No. EC155-71A015

ALERT SERVICE BULLETIN

POWER PLANT - Firewall

Modification of the material of the firewall edging

Figure 1

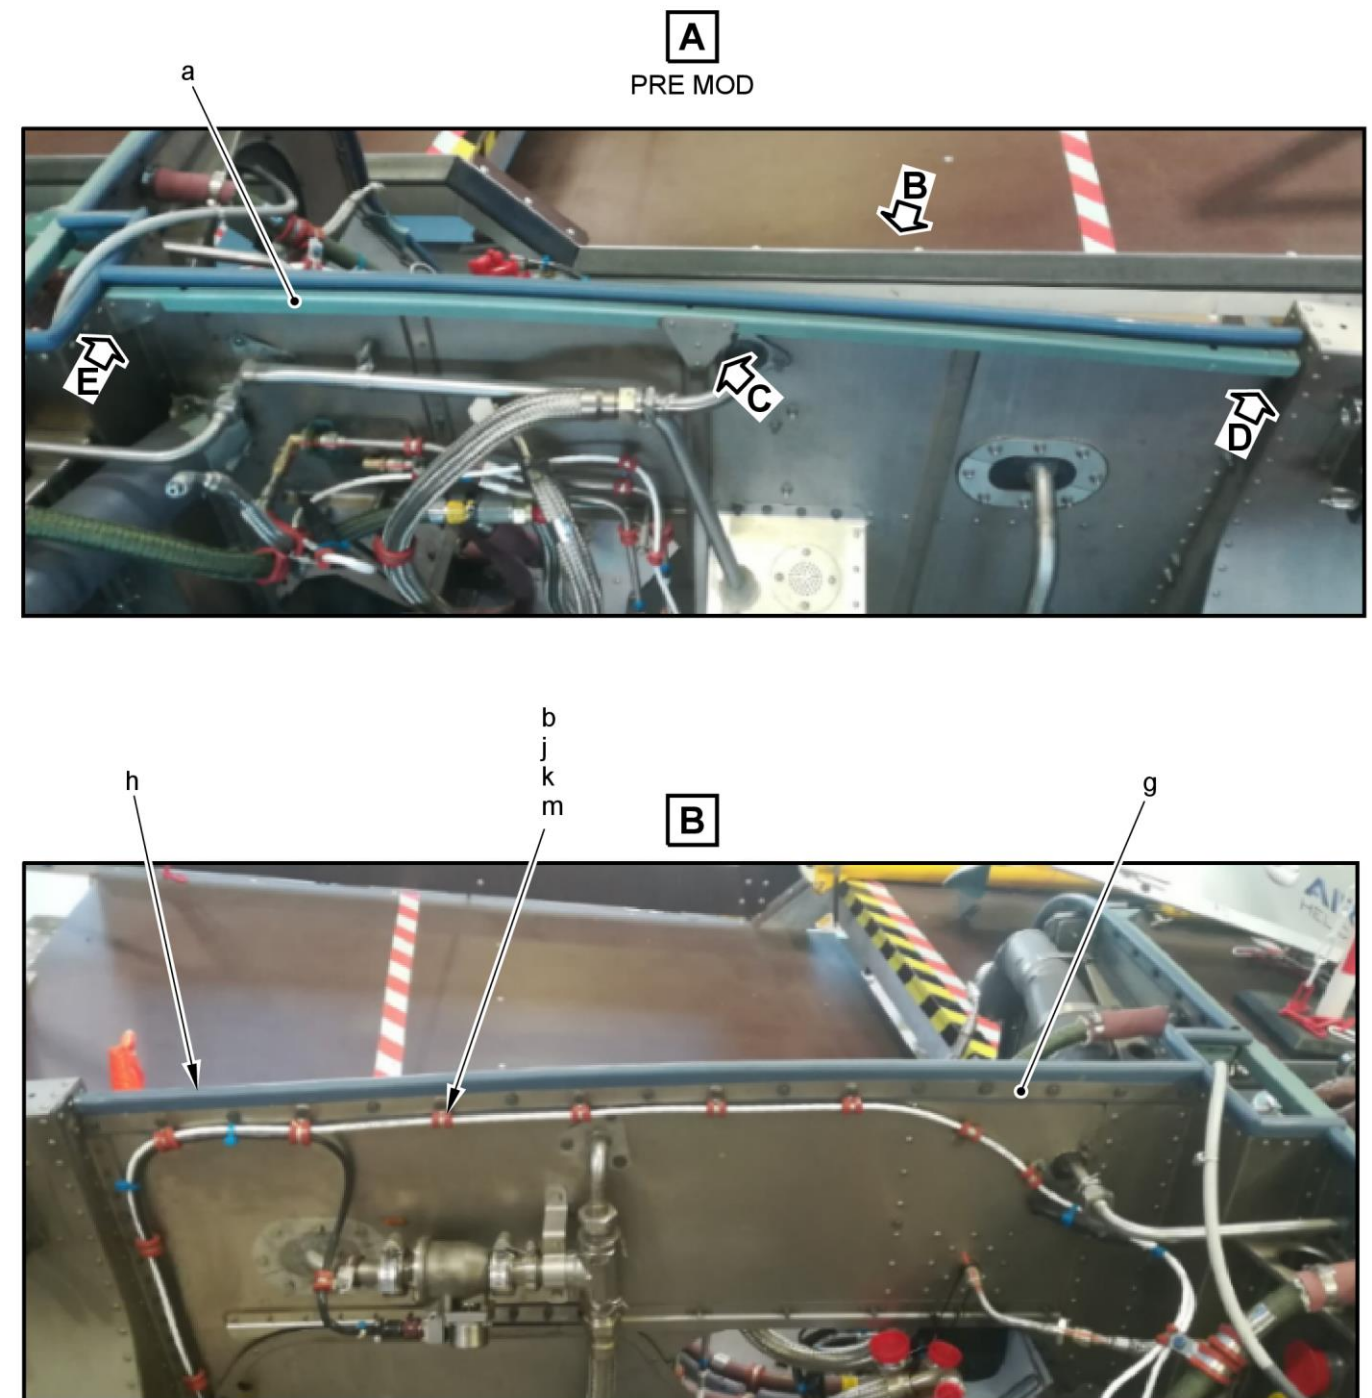
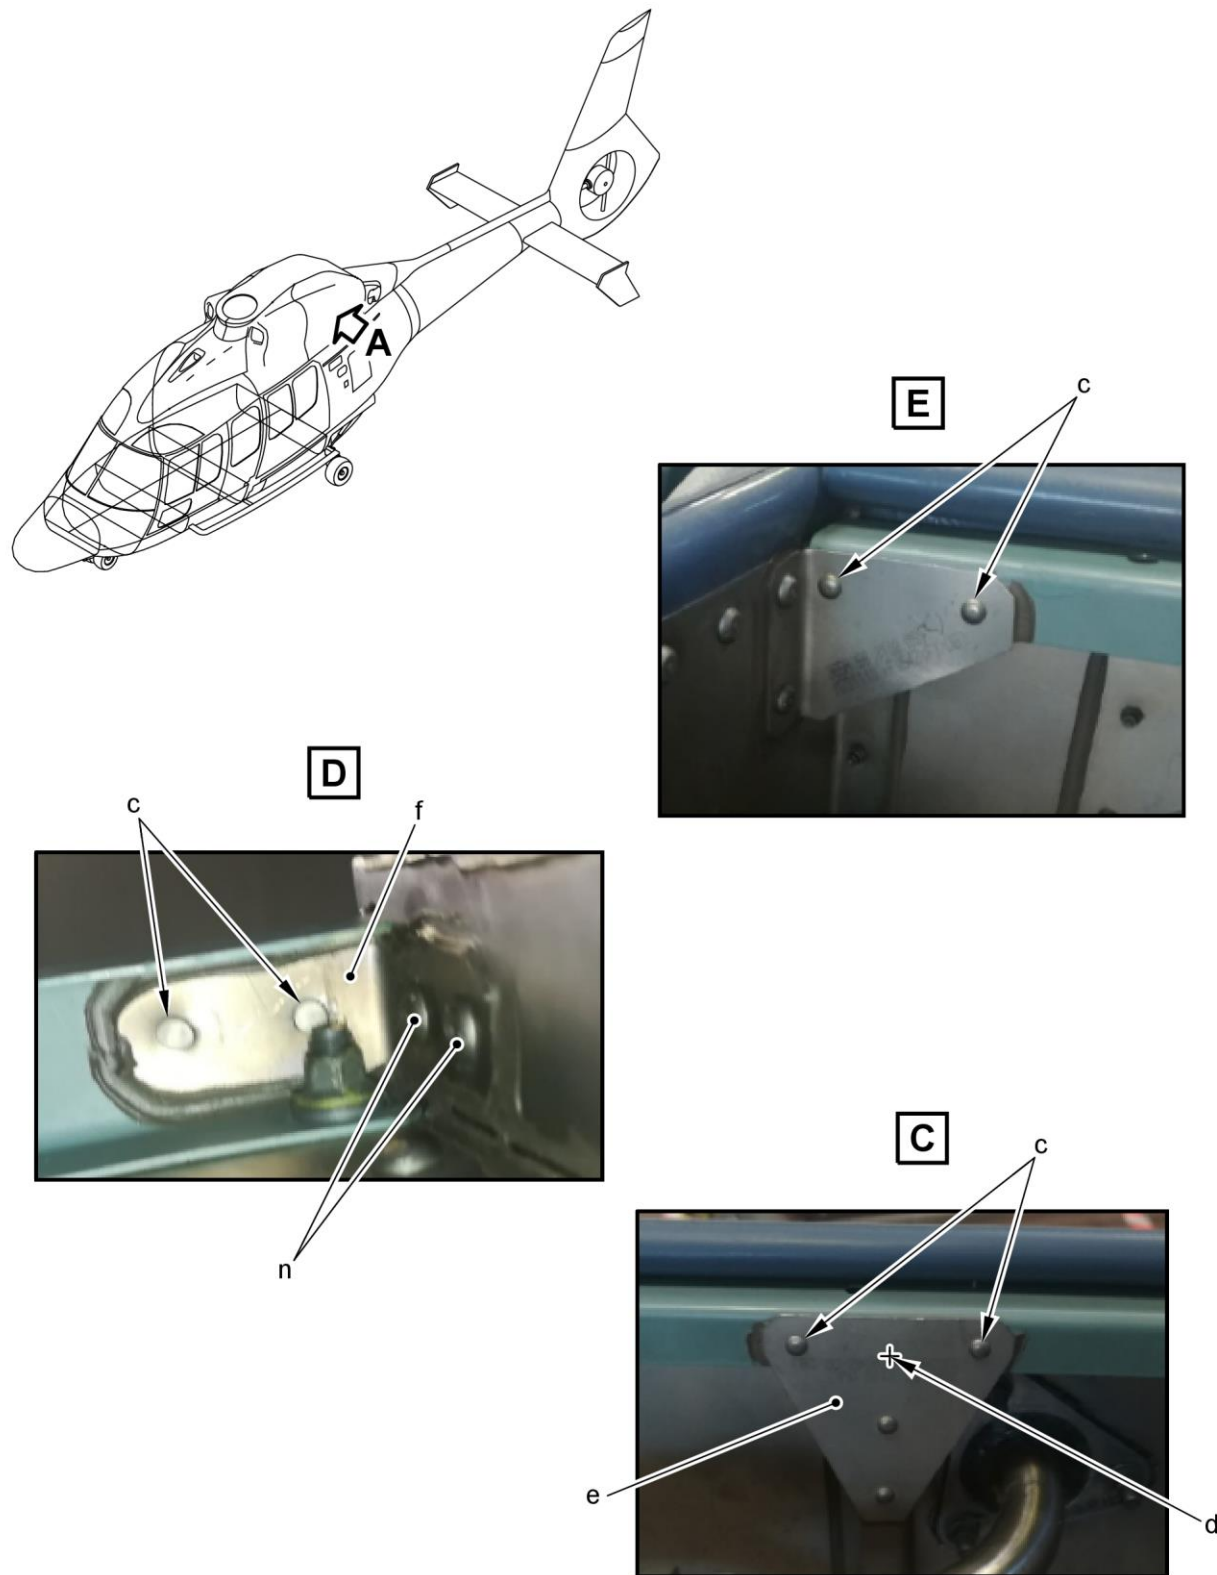
3.B.2.a. Removal of the aluminum stiffener from the firewall ([Figure 1](#))

Refer to DETAIL A, DETAIL C, DETAIL D and DETAIL E:

- Remove the rivets (c) from the stiffener (a). Refer to Work Card 20-03-01-102 (MTC).
- If the center rivet (d) is installed on the gusset (e) (DETAIL C):
 - . Remove the rivet (d). Refer to Work Card 20-03-01-102 (MTC).
- Remove and discard (DETAIL B):
 - . The stiffener (a)
 - . The bolts (b)
 - . The washers (j)
 - . The nuts (k).
- Remove and keep (DETAIL A, DETAIL B):
 - . The cover strip (g)
 - . The fireproof seal (h)
 - . The clamps (m).
- If the bracket (f) is in unsatisfactory condition (DETAIL D):
 - . Remove the rivet (n)
 - . Remove and discard the bracket (f).

Figure 2

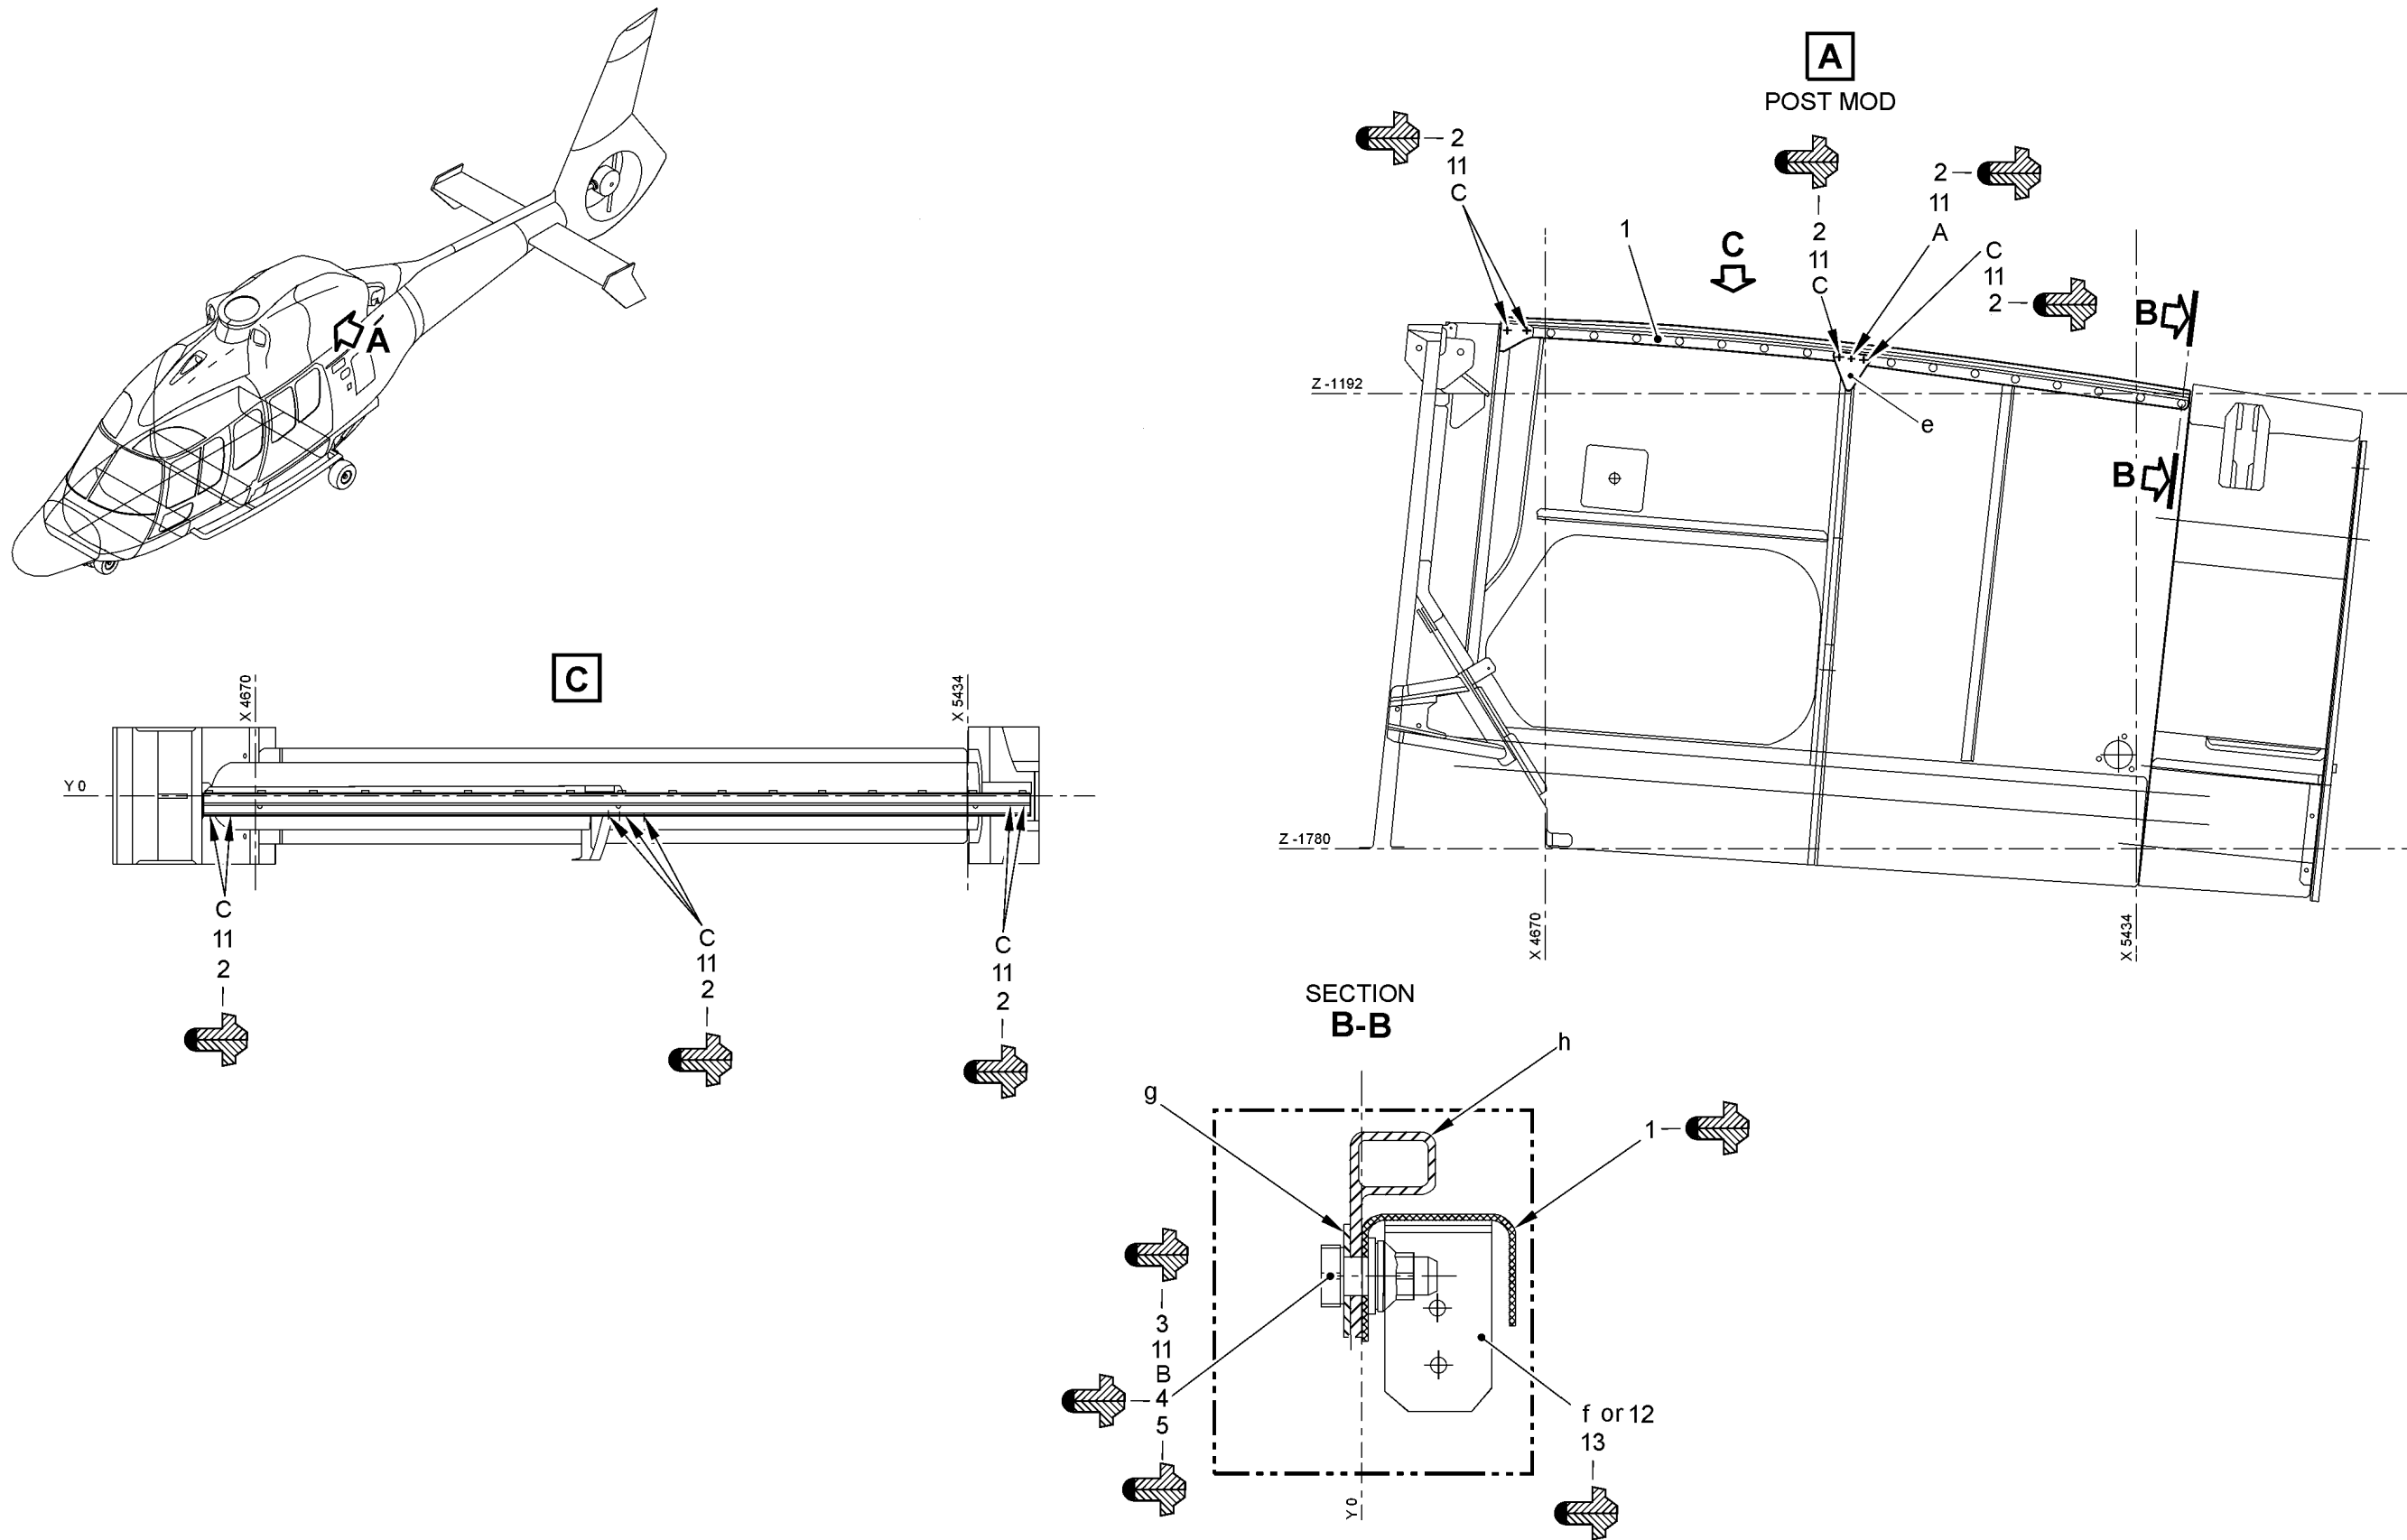
3.B.2.b. Installation of the titanium stiffener on the firewall ([Figure 2](#))

- Put in position the stiffener (1) on the firewall to agree with the existing holes.
- If there is a hole (A) on the gusset (e) (DETAIL A):
 - . Counter-drill the hole (A) to 2.4 mm diameter on the stiffener (1).

- Counterdrill the holes (B) to 5,5 mm diameter to agree with the existing firewall holes.
- Counterdrill the holes (C) to 2,4 mm diameter to agree with the existing firewall holes.

- Deburr and apply protection with interposition sealant (11) to the holes (A), (B) and (C). Refer to Work Card 20-05-01-227 (MTC).
- If the bracket (f) is removed:

- . Replace it with a new bracket (12) (SECTION B-B). Refer to paragraph [2.C.](#)
 - . Install the new bracket (12) on the firewall with rivets (13).
- Install all the rivets (2) on the stiffener (1), the gusset (e) and the bracket (12) or (f) with the sealing compound (14) (DETAIL A and DETAIL C). Refer to Work Card 20-03-02-401 (MTC) and Work Card 20-05-01-222 (MTC).

- Do a check of the cover strip (g) and the fireproof seal (h) to replace if necessary (SECTION B-B). Refer to Work Card 71-30-10-702 (AMM).
- Install the stiffener (1), the cover strip (g) and the seal (h) (DETAIL A, DETAIL C and SECTION B-B) with:

- . The bolts (3)
 - . The washers (4)
 - . The nuts (5)
 - . The clamps (m) (not shown)
 - . The sealing compound (14). Refer to Work Card 20-05-01-222 (MTC).
